LONDON AIRSPACE MANAGEMENT
PROGRAMME (LAMP) PHASE 1A

CAA DECISION: PART APPLICABLE TO
LAMP PHASE 1A MODULE E

CAP 1366/E

AIRSPACE CHANGE PROPOSAL – MODULE E

Diagrams to show proposed changes to controlled airspace in the Isle of Wight region – subjected to consultation, proposed and refined

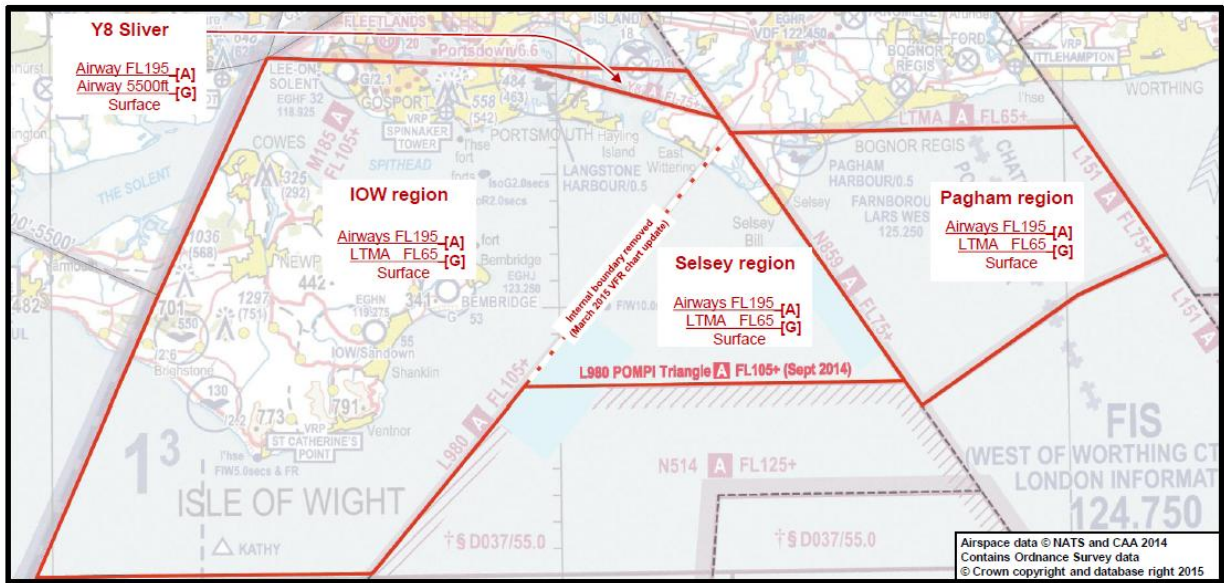
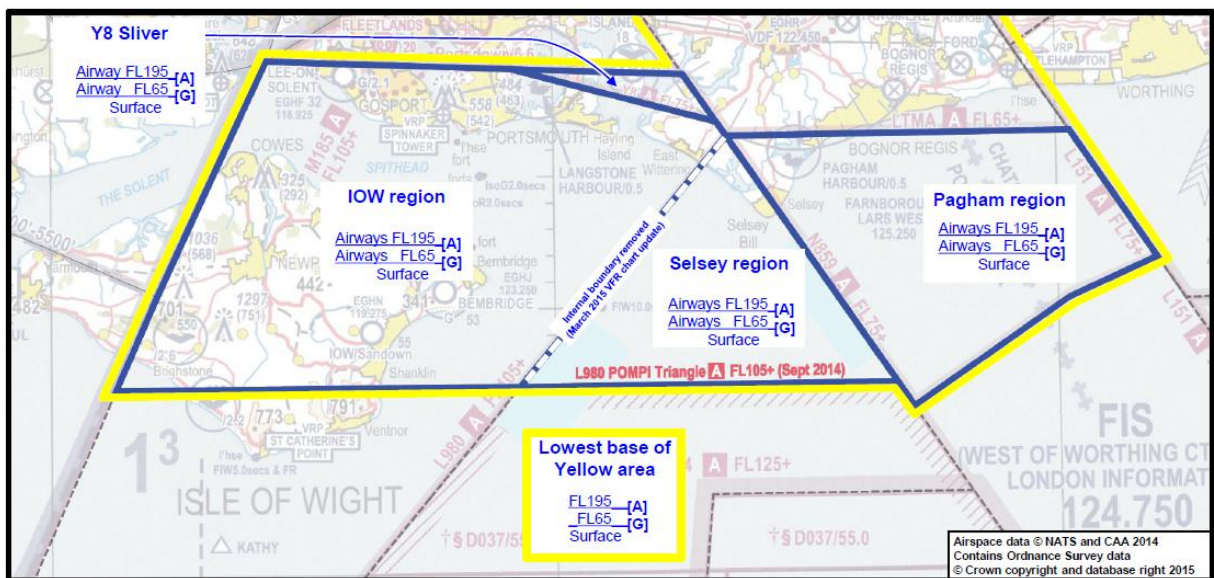
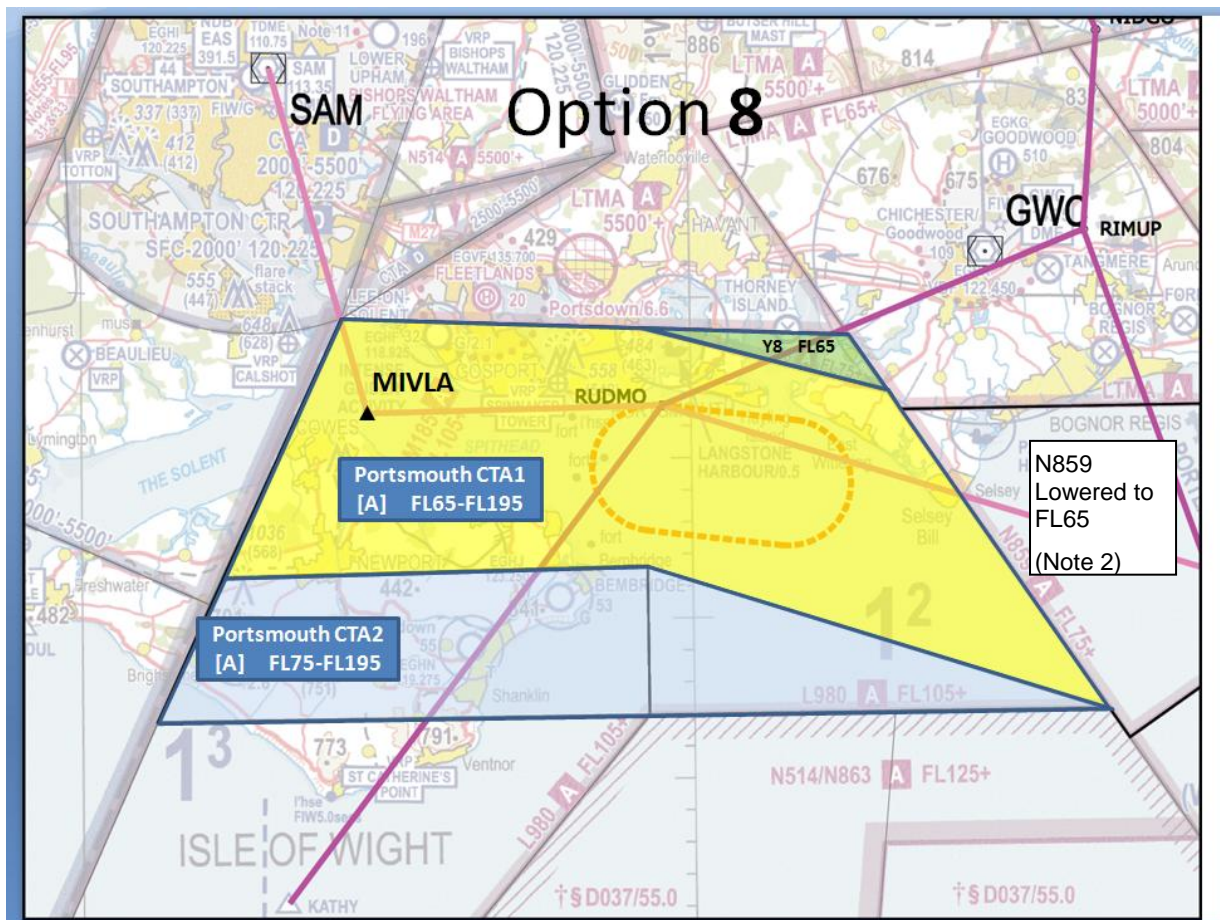
50. As a result, and as shown in the diagrams in Annexes A and B, the original proposal included a request to lower controlled airspace from FL105¹⁷ to FL65; following CAA intervention, NATS has now modified its request for controlled airspace down to FL75 in the southern portion of the area covered by this proposal. A chronology setting out the iterations and refinements of the proposed lower limits of controlled airspace over the Isle of Wight is detailed in Annex D.¹⁸

- D5. Following discussions between CAA and NATS, it was determined that the southern portion of the area proposed at FL65 could be raised to FL75. This partly mitigates some of the potential impacts on GA whilst having a negative, but tolerable, impact on operational efficiency.

1. The Y8 sliver (in green) has subsequently been combined with Portsmouth CTA 1.
2. The area of N859 as proposed in the consultation as the Pagham Region is lowered to FL65.
3. See the diagram in the AIC Y076/2015 (Annex B) to show the final airspace structure.

- D7. Subsequently, after the revised proposals were reviewed by the CAA decision maker, the proposed controlled airspace has now been further reduced; the lower limits are now FL65 to the north and FL75 to the south. A diagram extracted from the AIC Y076/2015 is attached at Annex B to illustrate the new airspace structure now proposed and on which the CAA has taken its decision.

New controlled airspace in the Isle of Wight region – Portsmouth CTA

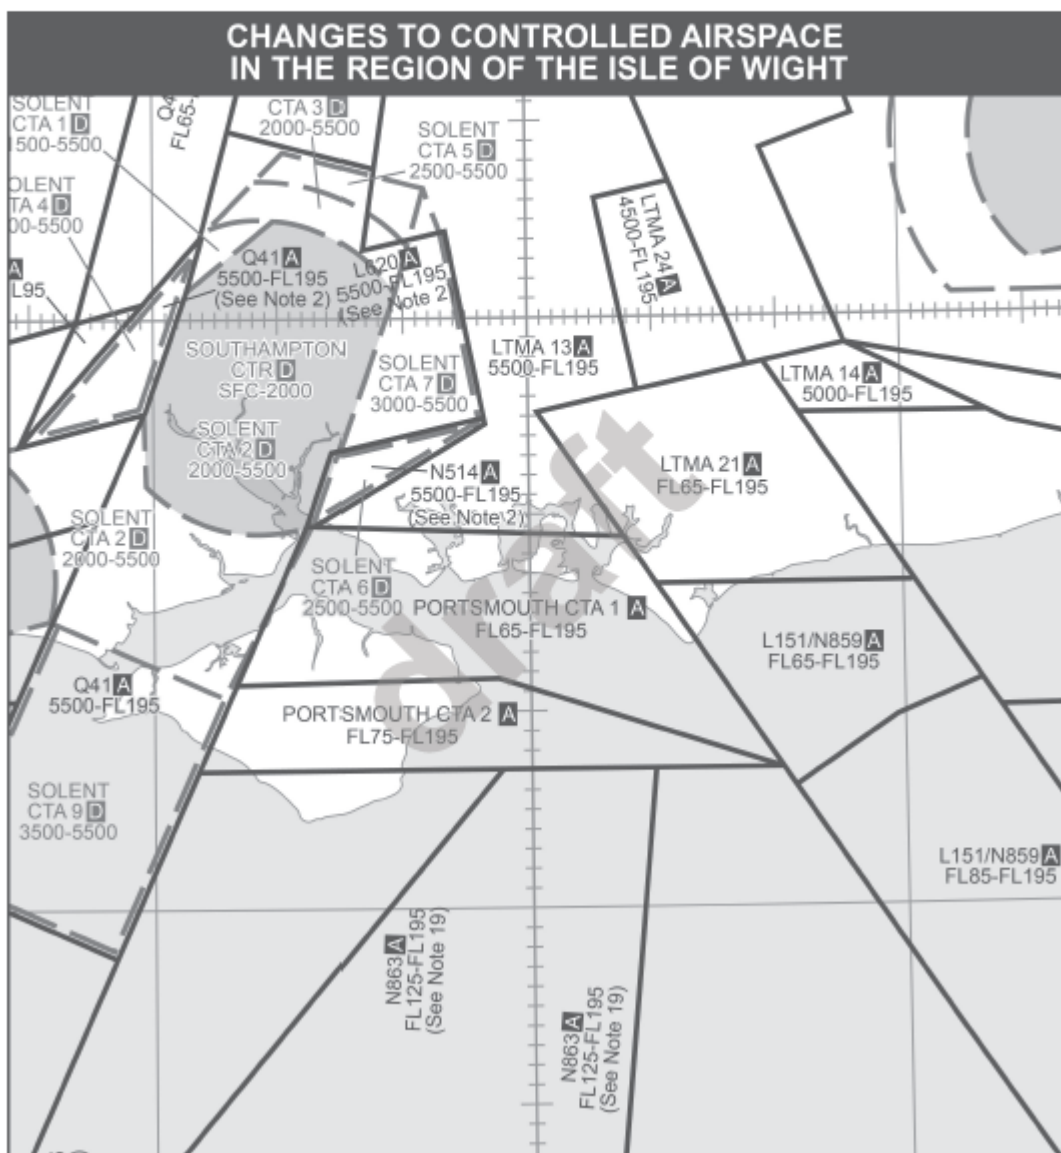
Part of L151/N859 is lowered from FL 75 to FL 65.

Part of L980 (known as the POMPI Triangle) L980/M185 and the Y8 sliver are lowered to FL85 and become the Portsmouth Control Area 1.

Part of L980 (known as the POMPI Triangle) L980/M185 are lowered to FL75 and become Portsmouth Control Area 2.

The existing LTMA Sector 22 (lower limit 5500 ft) located to the east of the Solent CTA7, is amalgamated with LTMA Sector 13 (no change in lower limits).

87. We have decided that in order to achieve the anticipated benefits consequential on the airspace change proposed in Module E, the CAA will approve this change. The changes approved to controlled airspace are shown in Annex B.
